**1958 Agreement – Consideration of draft amendments
to existing Regulations submitted by GRSG**

Proposal for the 02 series of amendments to Regulation No. 118 (Burning behaviour of materials)

Submitted by the Working Party on General Safety Provisions *

Figure 1
Specimen holder (Dimensions in millimetres)

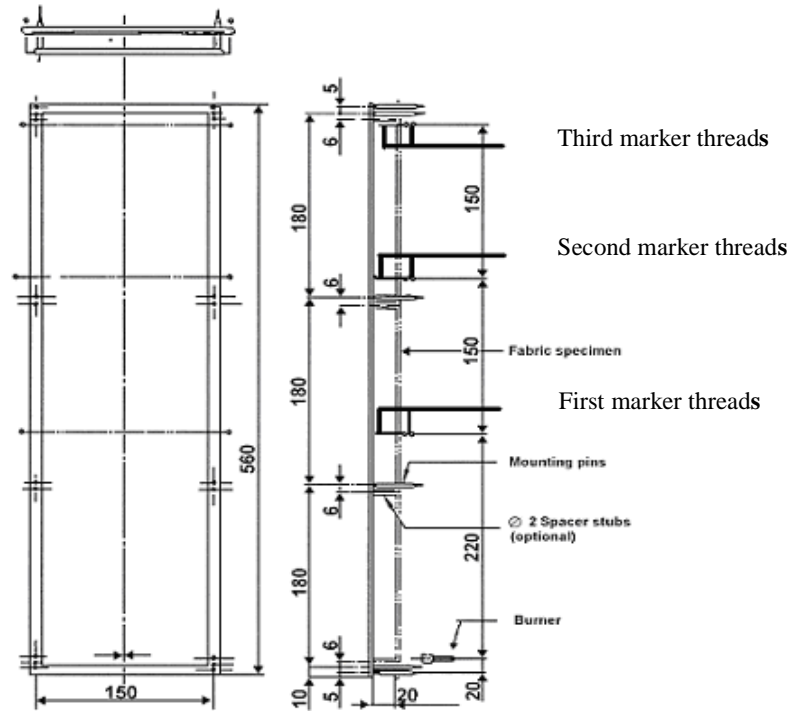
Annex 8, figure 1, amend to read:
